Subject: Grand Gulf Nuclear Station  
Docket No. 50-416  
License No. NPF-29  
Response to Request for Additional Information RE: Revision  
of Technical Specifications for Emergency Diesel Generator  
Lube Oil Inventory (TAC NO. MB0423) LDC 1999/083

GNRO-2001/00048

**FIRE HAZARDS ANALYSIS REPORT  
REVISION REQUEST**

Engineering Fire Hazards Analysis Report Revision Request (FHAR) Number: 99-0004

### Sketch #1

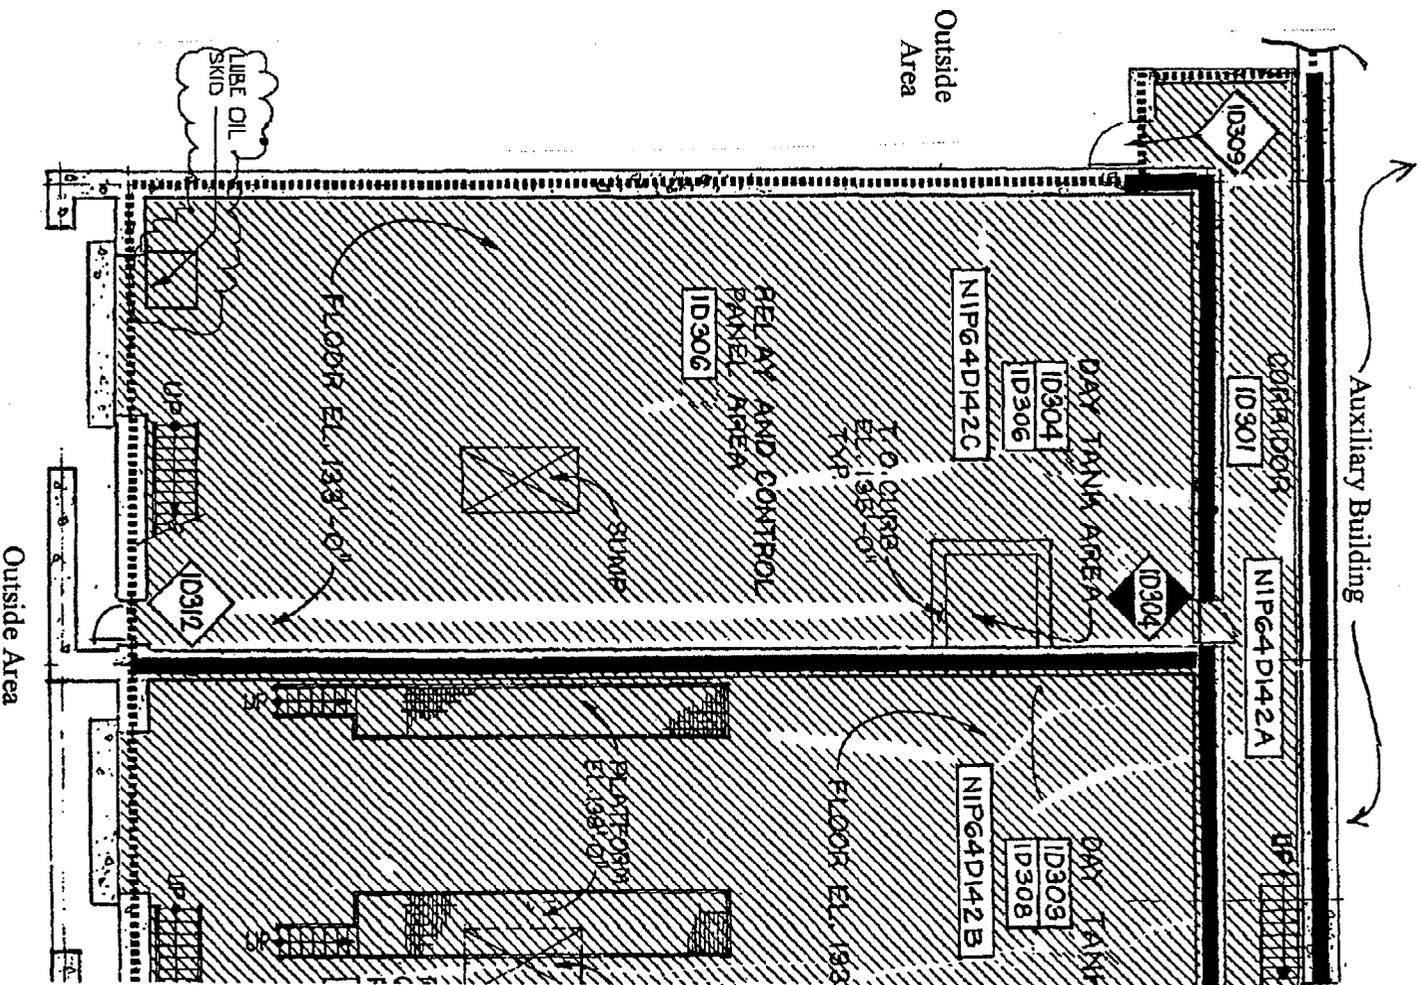
- b. Provide either a detailed diagram or detailed written description to describe the relationship of the lube oil storage skid and the Division I, II, and III EDGs to the following:
- combustibles
  - potential ignition/heat sources
  - safe shutdown equipment or cables
  - rated fire barriers/doors
  - automatic suppression and detection systems
  - manual fire protection features
  - ventilation systems

The lube oil storage skid will be located on the north end along the west wall of the Div. III EDG Room (Fire Zone 1A306/Fire Area 63) as indicated in Sketch #1. Sketch #1 is a partial view taken from Drawing A-0634 "Unit 1 Aux. & Diesel Gen. Bldg. and SSW Pump House – Fire Protection Floor Plans at El. 133'-0" & 139'-0". Fire Area 63 is separated from all other areas by

3-hour rated fire barriers and it contains no Appendix R safe shutdown components. The nearest combustibles to the lube oil skid are the lube oil in the west engine of the Div. III EDG (approximately 6' to the east) and electrical cables in trays (approximately 20' to the south and approximately 15' above floor level). The nearest fixed ignition source other than the diesel engine is electrical control panels located approximately 18' to the south of the oil storage skid. Protection for Fire Area 63 consist of area wide automatic pre-action sprinkler system, actuated by heat detectors, ultraviolet flame detection for early warning, and accessibility to manual hose streams and portable fire extinguishers. All suppression and detection system alarms annunciate in the main control room. The area where the oil skid is located is an open area that is adequately covered by the existing detection and suppression systems. Ventilation for this area consists of room supply fans with exhaust through the Diesel Generator Building Corridor (Room 1D301) to the outside. The major contributor's to the combustible loading in this area is the lube oil in the engines and diesel fuel oil. Currently the in situ loading is <45 minutes, the addition of the 3-55 gallon drums of lube oil and fill hose to this area increases the loading to <60 minutes. Fire Area 63 contains no safe shutdown components, total combustible loading will be <60 minutes, and this area is separated from other areas containing safe shutdown components by 3-hour rated fire barriers. Therefore, a fire in fire area 63 will not damage or propagate to damage redundant safe shutdown components.
